DOCUMENT 00 90 00 ADDENDUM

ADDENDUM No.: 4

RE: LA CROSSE HOUSING AUTHORITY

2024 CAPITAL IMPROVEMENT PROJECTS

2 2ND FLOOR LIGHTING DEMO
1/8" = 1'-0"

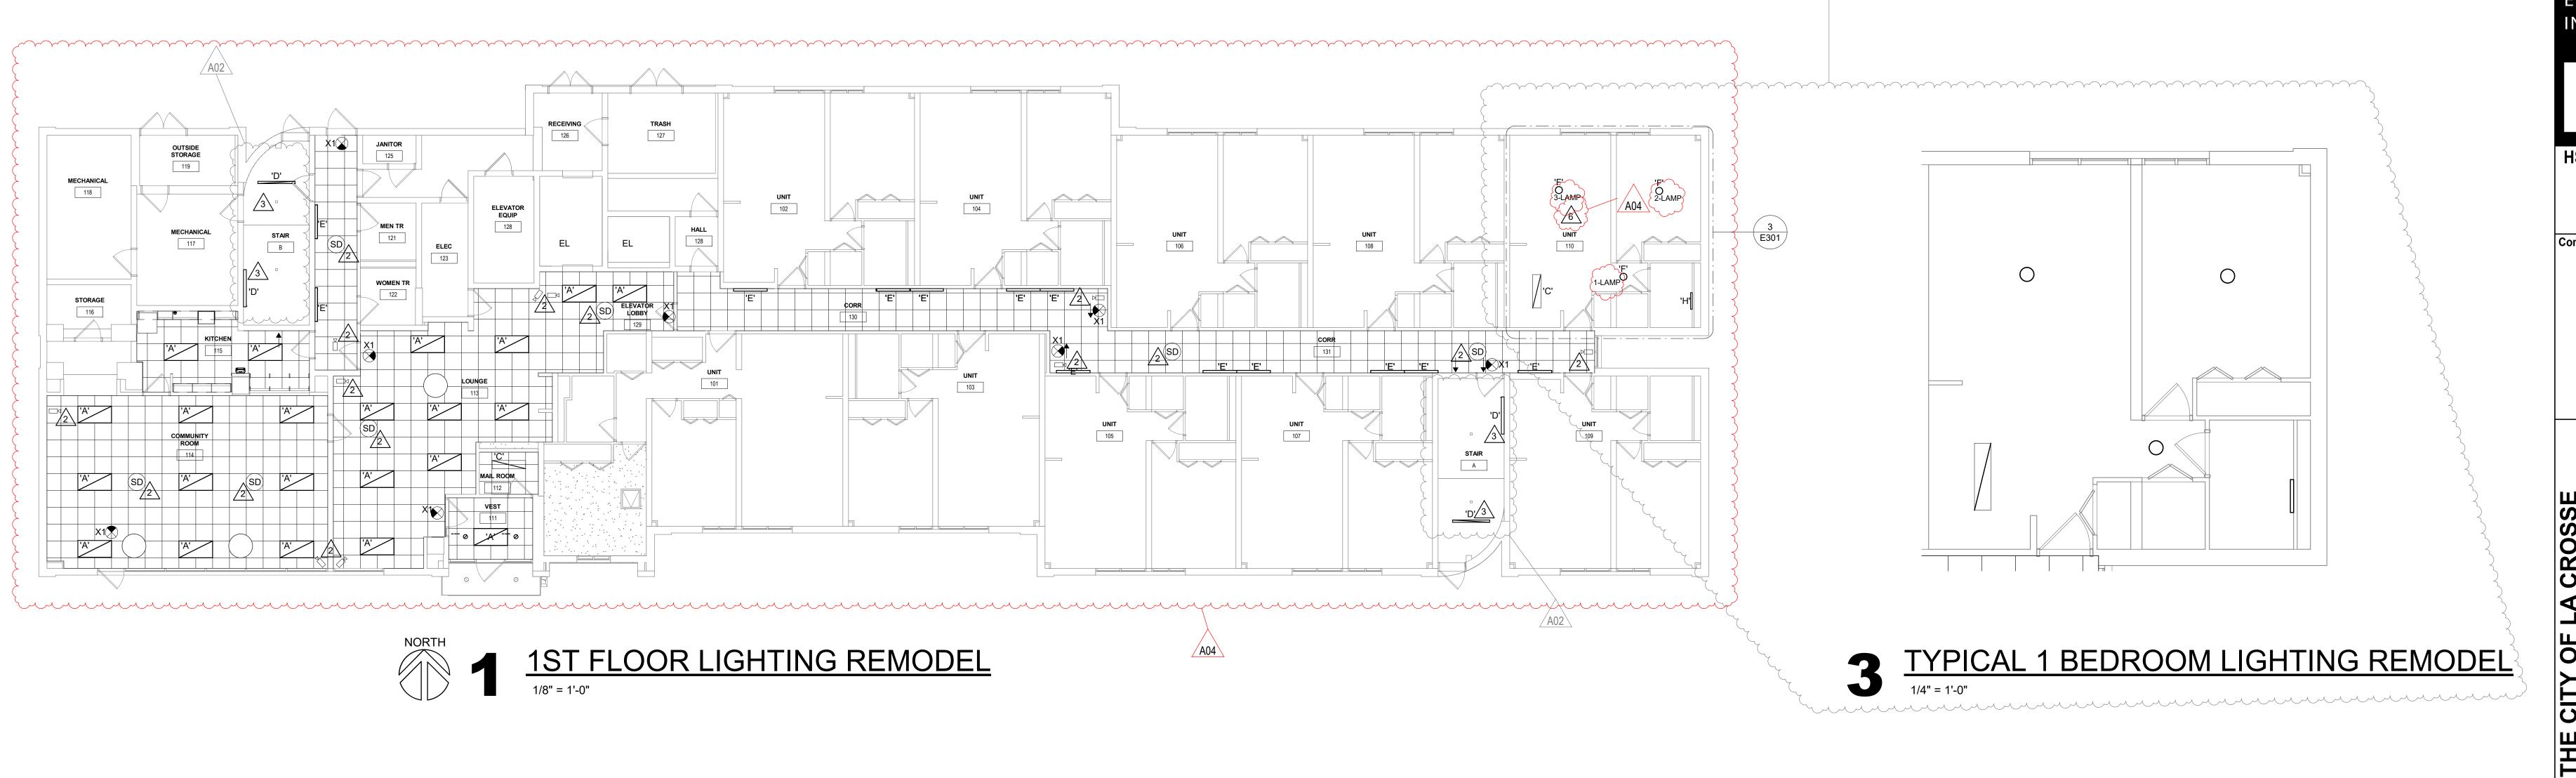
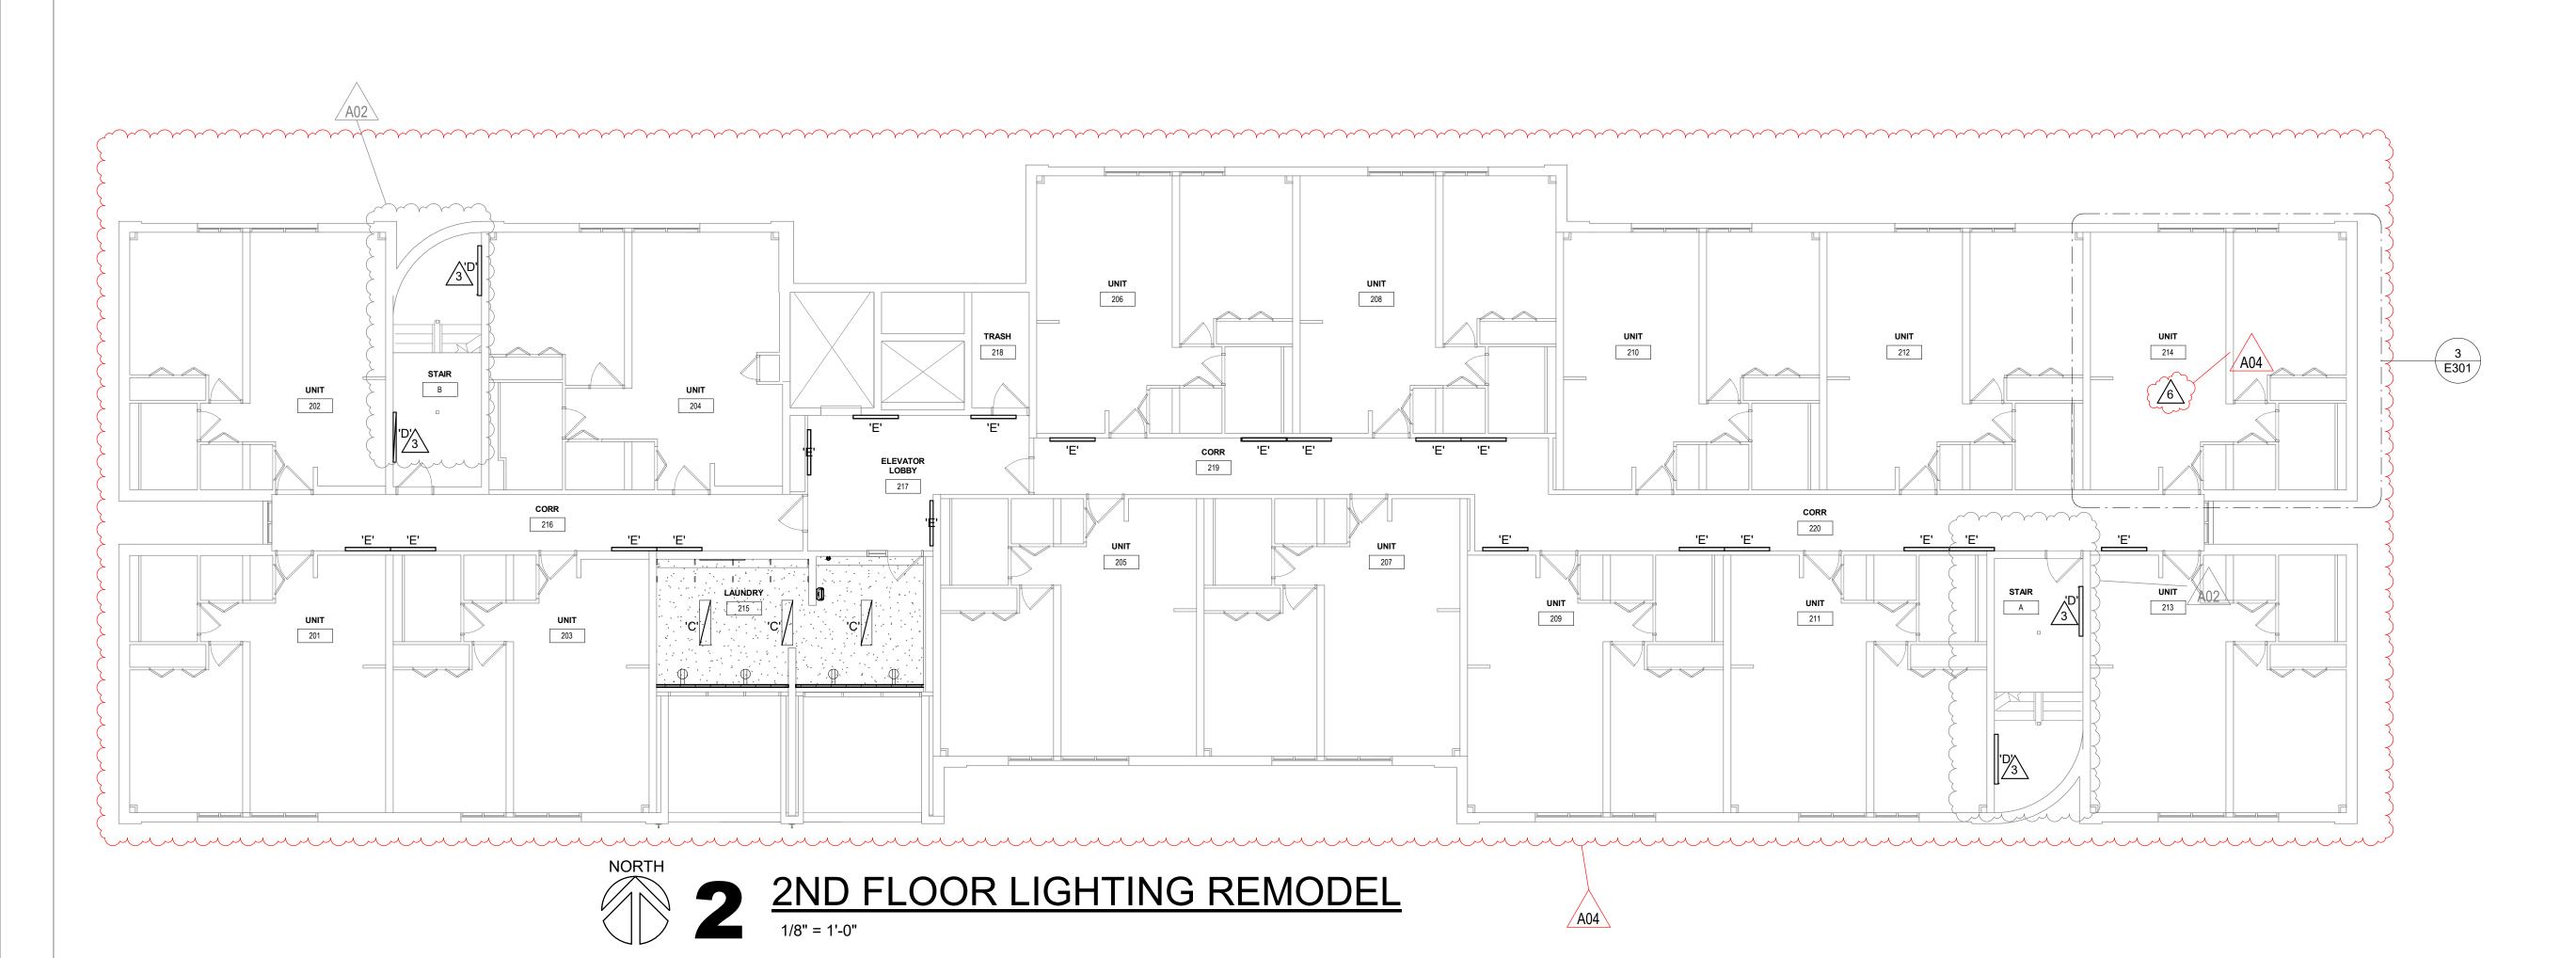
- a. See the revised sheet included in this addendum. Disregard the previous version.
- b. Clarified fixture name/model/description in schedules.
- c. Added room names and numbers.
- d. Added Key Note 6 regarding removal and installation of lights in all 1 bedroom units in the building.

E301

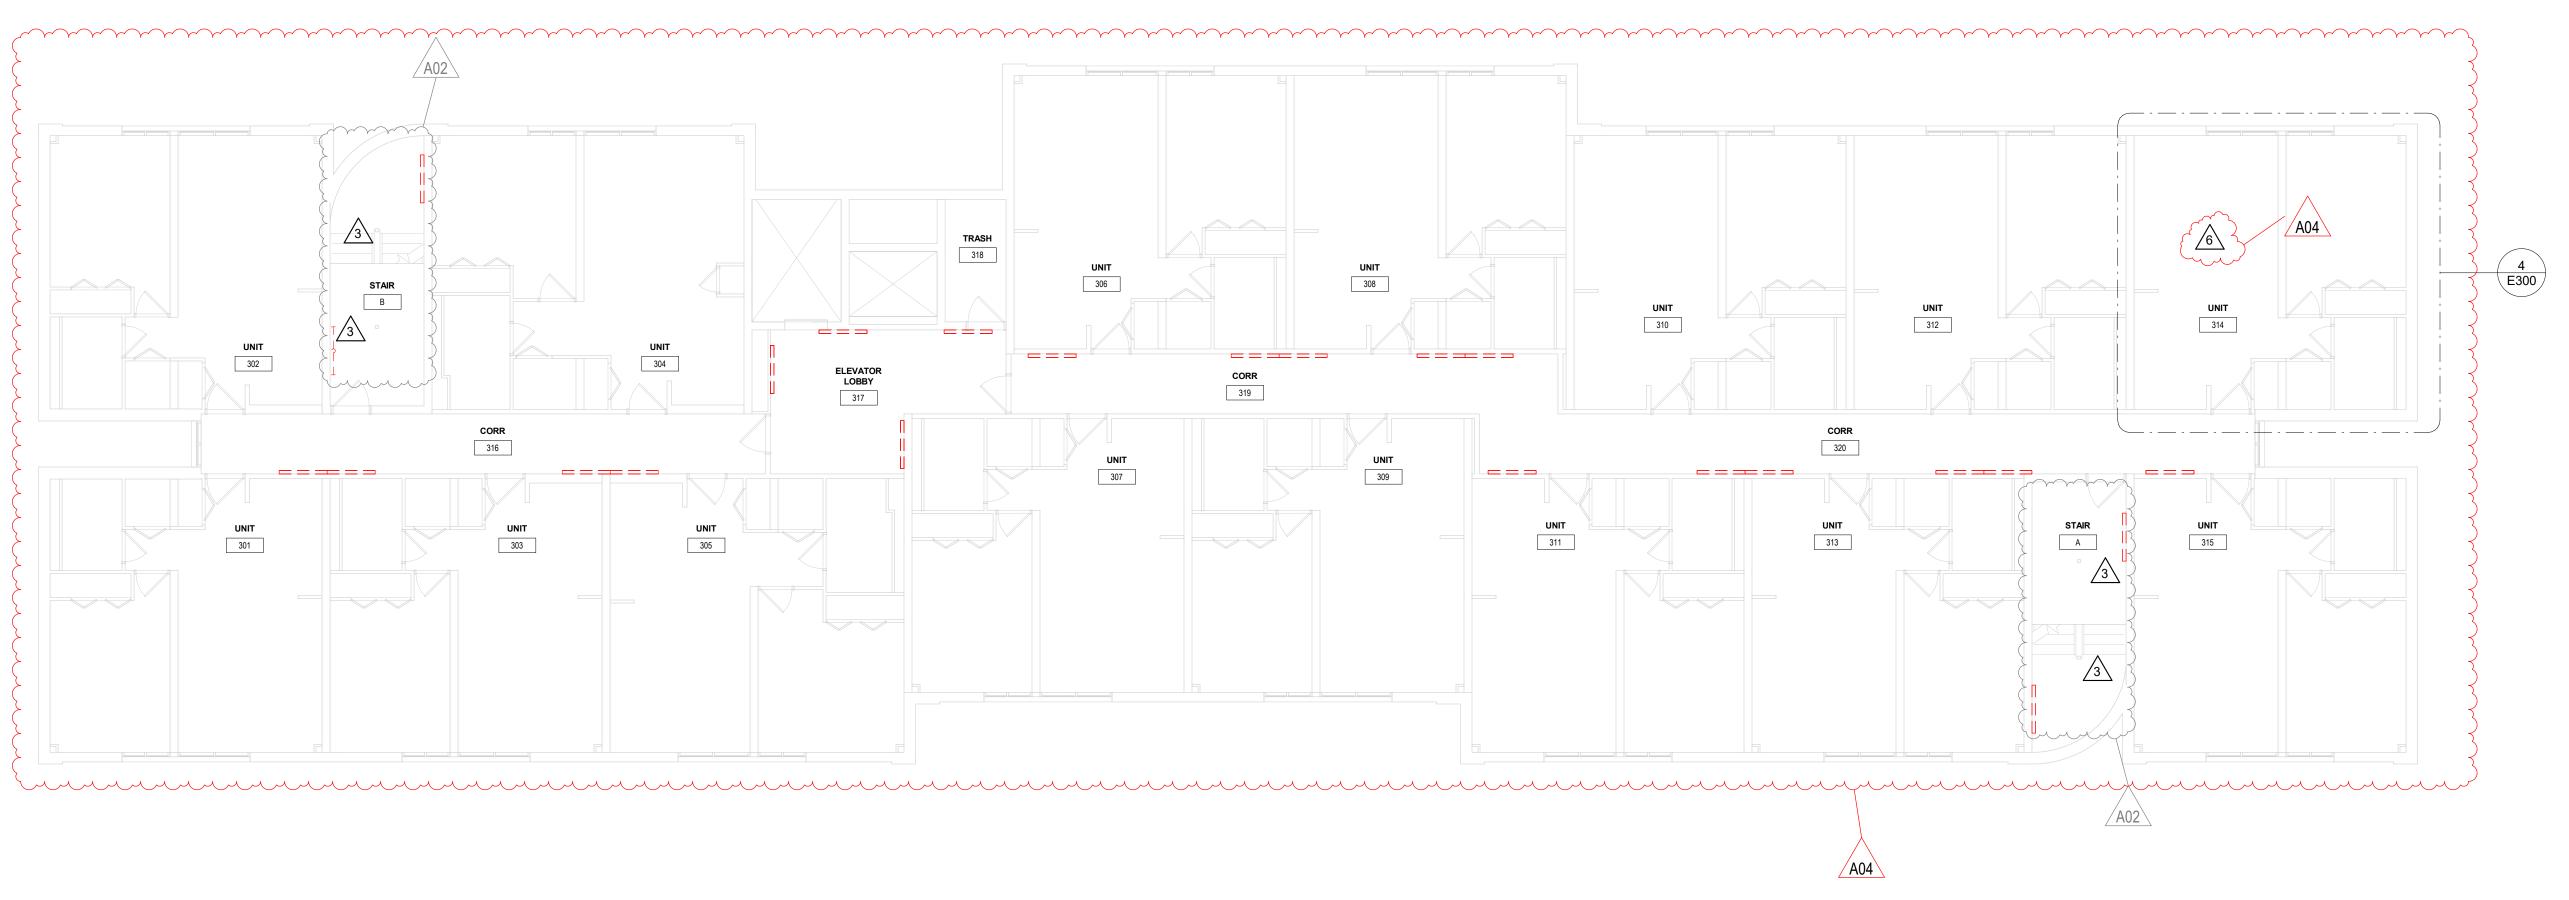
- a. See the revised sheet included in this addendum. Disregard the previous version.
- b. Clarified fixture name/model/description in schedules.
- c. Added room names and numbers.
- d. Added Key Note 6 regarding removal and installation of lights in all 1 bedroom units in the building.

## 2 6TH FLOOR LIGHTING DEMO 1/8" = 1'-0"

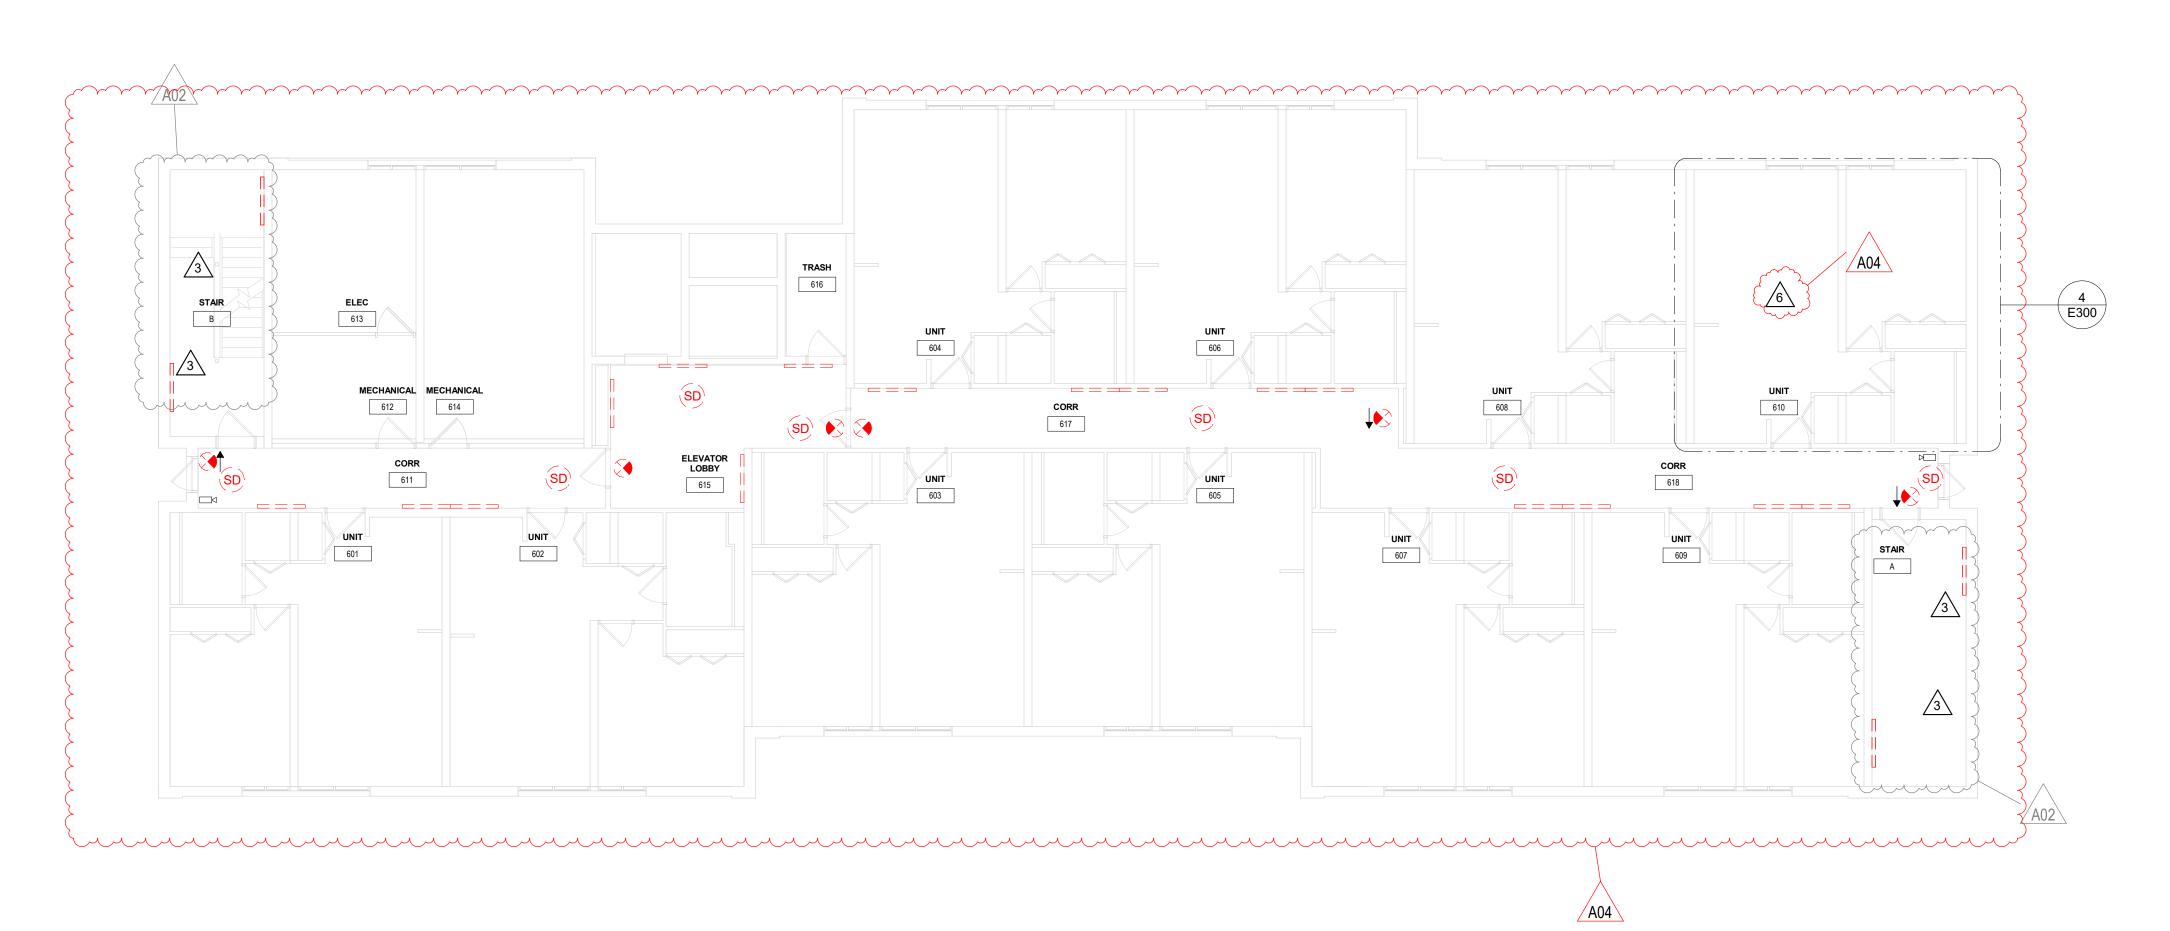
- a. See the revised sheet included in this addendum. Disregard the previous version.
- b. Clarified fixture name/model/description in schedules.
- c. Added room names and numbers.
- d. Added Key Note 6 regarding removal and installation of lights in all 1 bedroom units in the building.
